Objections to the Proposed Development at 75 Lawn Road, NW3 2XB (Application ref: 2020/3726/P) – CHANGES TO REAR OF HOUSE

Objections in relation to design and loss of amenity from Application 2020/3726/P

Figure 4: a) CAD included in App 5 (2020/3726/P) documents fails to show the “rising land” referenced by the Planning Inspector. b) 1 metre height steps between ground floor level and garden level (2nd below) – applicants’ photo taken from 1st floor at No.75.

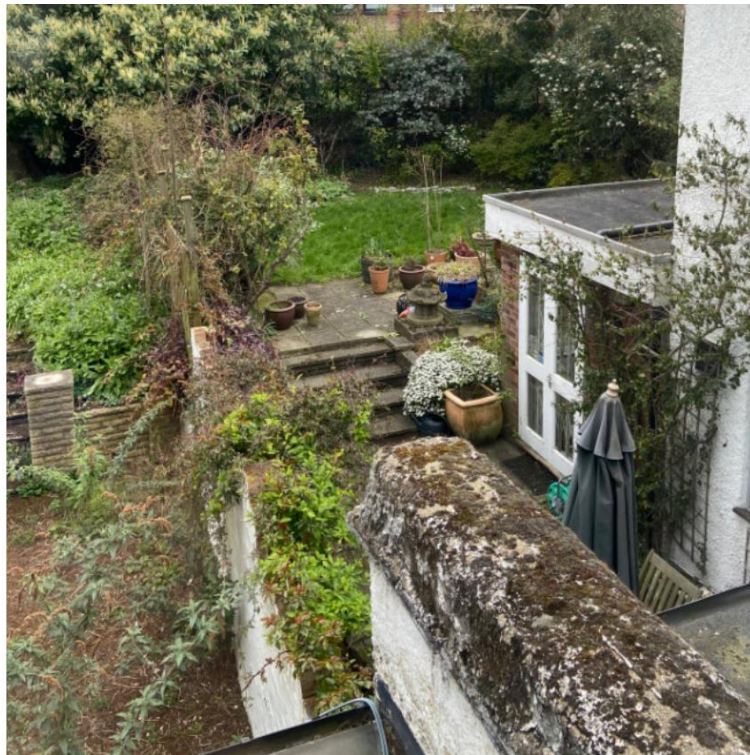
2.13 We note that the "rising land" described by the Planning Inspector has vanished in the CAD images submitted by this application, as was the case in previous applications (e.g. Figure 5).

2.14 We object to the proposed first floor extension of the outrigger side wall because the new size, massing and position in front of and above our rear windows and main patio will have a significant detrimental impact on the amenity of No.74 Lawn Road, creating overbearing, poor outlook, overshadowing, and sense of enclosure.
